# Access Compliance Report

## Public Rights-of-Way

### (Curb Ramps)

Intersection ID: 48454	Main Street: RED_RUST_LN	Cross Street: GOLF_LINKS_DR	Location: NW
ADA ID: 16F1CAE620E5	Ramp Type: Perp	Initial Pass/Fail: Fail	Overall Compliance: No
		Severity Score: 1.25

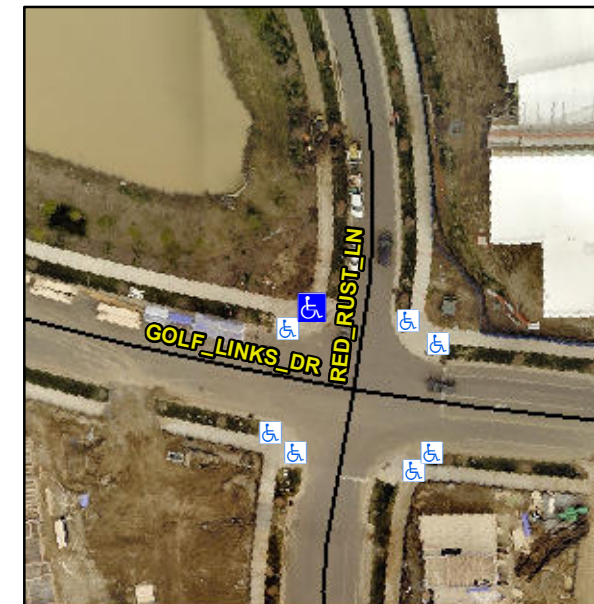
**Not Found, R304.5.3**

Compliance	Description	Data	Compliance	Description	Data
N/A	Ramp Length (in)	93.0	Yes	Ramp Slope (%)	6.8
Yes	Ramp Width (in)	60.0	No	Ramp XSlope (%)	2.6
N/A	Flare Type LT	N/A	N/A	Flare Type RT	N/A
N/A	Flare Slope LT (%)	N/A	N/A	Flare Slope RT (%)	N/A
N/A	Flare Traversable LT?	N/A	N/A	Flare Traversable RT?	N/A
N/A	Landing Length (in)	N/A	N/A	DWS Provided?	N/A
N/A	Landing Width (in)	N/A	N/A	DWS Contrast?	N/A
N/A	Landing Slope (%)	N/A	N/A	DWS Length (in)	N/A
N/A	Landing X Slope (%)	N/A	N/A	DWS Full Width?	N/A
N/A	Landing Curb? (Y/N)	N/A	N/A	DWS Offset (in)	N/A
N/A	Shared Landing?	N/A			
N/A	Gutter Ponding?	N/A	N/A	Gutter Slope (%)	N/A
N/A	Gutter Lip Ht (in)	N/A	N/A	Gutter X Slope (%)	N/A
N/A	Painted X Walk1?	No	N/A	Painted X Walk2?	N/A
	X Walk 1 Direction	To E		X Walk 2 Direction	N/A
N/A	X Walk 1 Width (in)	N/A	N/A	X Walk 2 Width (in)	N/A
	X Walk 1 Slope (%)	5.5		X Walk 2 Slope (%)	N/A
	X Walk 1 X Slope (%)	4.9		X Walk 2 X Slope (%)	N/A

**Remove & Replace Entire Ramp.**
